**Well Name:** EAGLE 33 O FED

### Notice of Intent

**Type of Action:** Plug and Abandonment

**Permanent Abandonment of Federal Wells**  
**Conditions of Approval**

EAGLE 33 O FEDERAL #11 Plugging Procedure

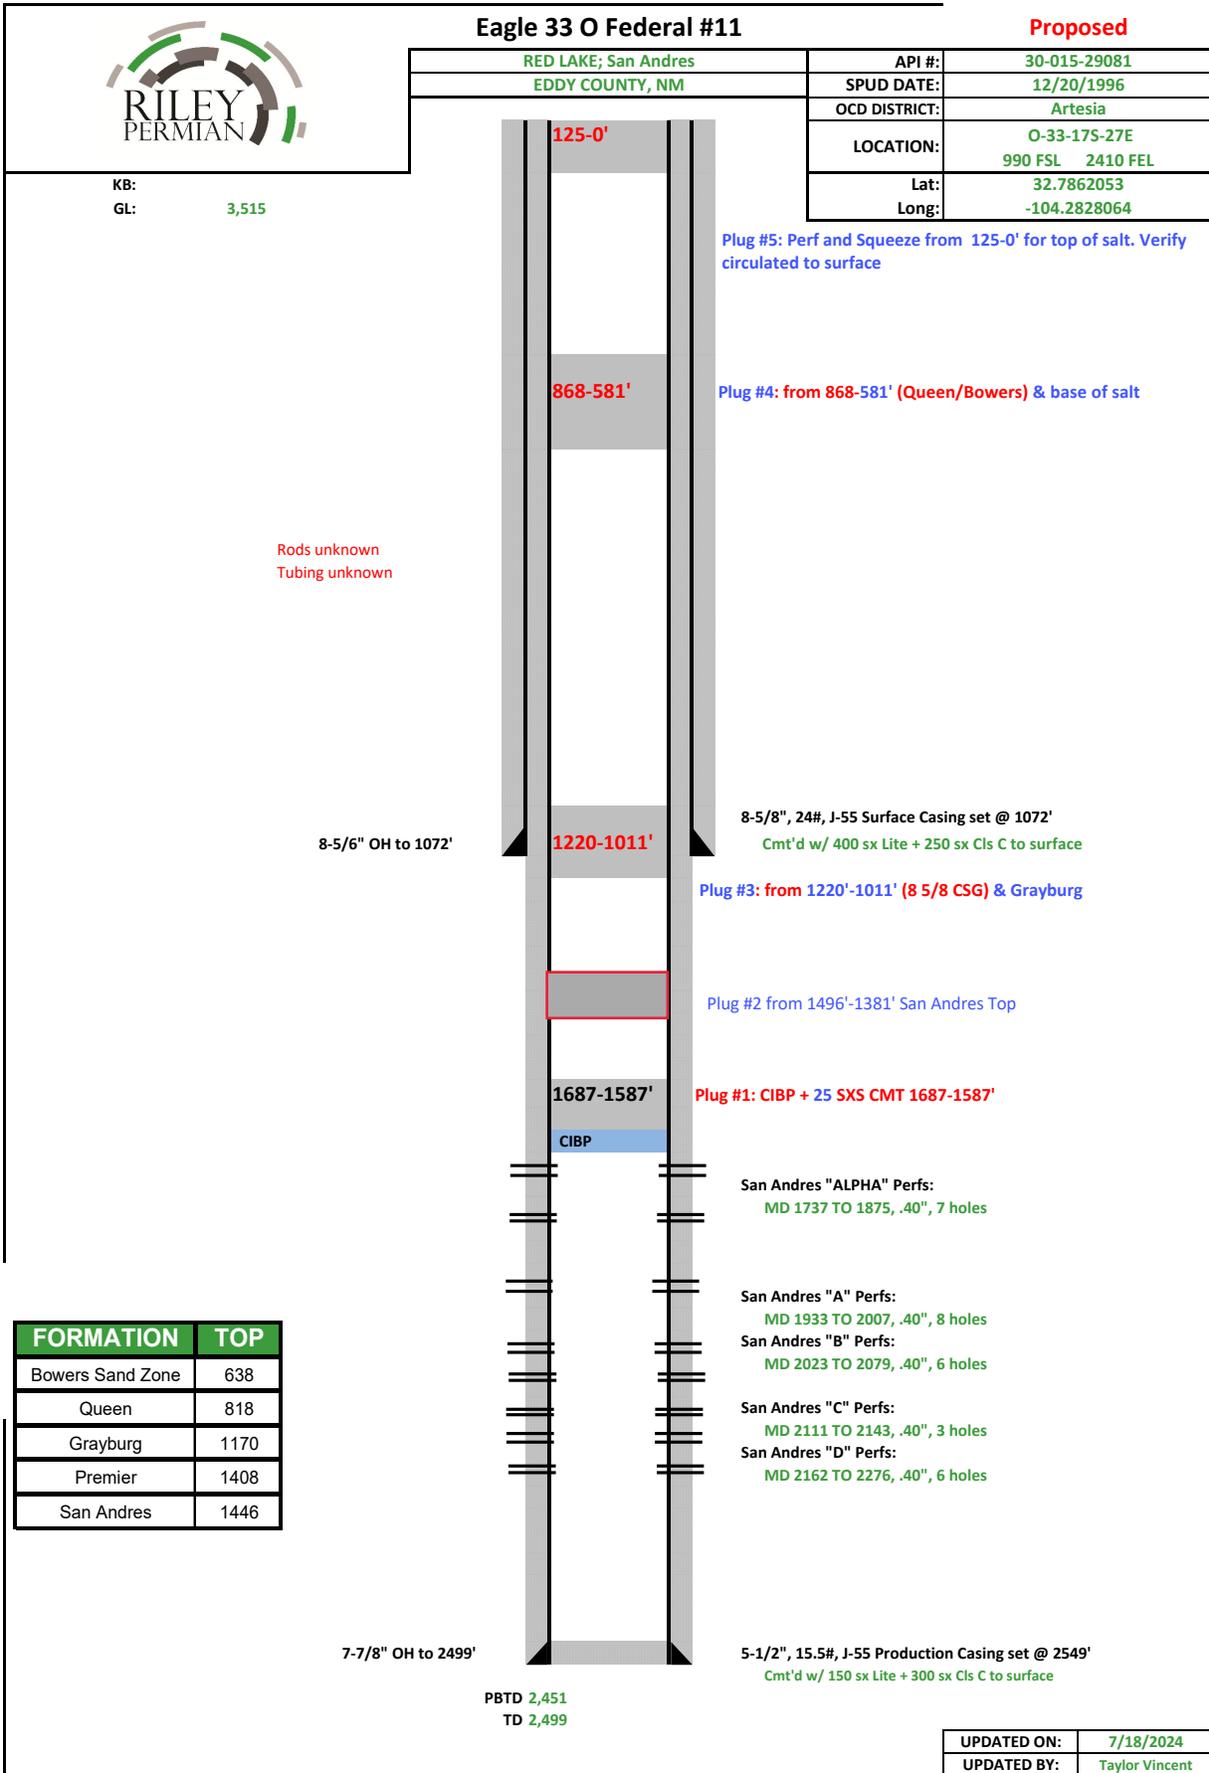
1. MIRU Rig and CMT Equipment. Check anchors if not using Basebeam.
2. ND WH, NU BOP (Function Test).
3. POH w/Production.
4. RIH w/HM plug to 1687'. Load Hole w/Mud. Plug #1 25 SXS 1687-1587'.
5. LD TBG to 1122'. POH w/TBG. RUWL CBL to Surface (\*)
6. **RIH w/TBG. Plug #2: from 1496-1381' San Andres Top WOC & Tag**
7. **RIH w/TBG. Plug #3: from 1220-1011' (8 5/8 CSG) & Grayburg WOC & Tag**
8. **LD TBG to 868'. Plug #4: from 868-581' (Queen/Bowers) & base of salt WOC & Tag**
9. **LD TBG to 125'. Plug #5: from 125-0' Perf and Squeeze from top of salt verify circulated to surface**
10. RDMO PU, transport trucks, and equipment. Cut off WH 3' below ground level & Install dry hole marker. Cut off anchors.

Plug Type	Top	Bottom	Length	Tag	Cement Class	Notes
Surface Plug	0.00	125.00	125.00	Verify Circulated To Surface	Class C	Perf & Squeeze
Top of Salt @ 75	0.00	125.00	125.00			
Base of Salt @ 638	581.00	868.00	287.00	WOC & TAG	Class C	Balanced Plug
Queen @ 818	581.00	868.00	287.00			
8.625 inch- Shoe Plug	1011.00	1220.00	209.00	WOC & TAG	Class C	Balanced Plug
Grayburg @ 1170	1011.00	1220.00	209.00			
San Andres @ 1446	1381.00	1496.00	115.00	WOC & TAG	Class C	Balanced Plug
CIBP Plug	1587.00	1687.00	100.00	WOC & TAG	Class C	500psi leak test 30mins

<u>Cave Karst/Potash Cement Requirement:</u>	<u>High</u>	<u>Bottom of Karst/take deepest fresh water/top of salt whichever is greater to surface</u>
8.625 inch- Shoe Plug @	1072.00	
5.5 inch- Shoe Plug @	2500.00

CIBP @ 1687.00
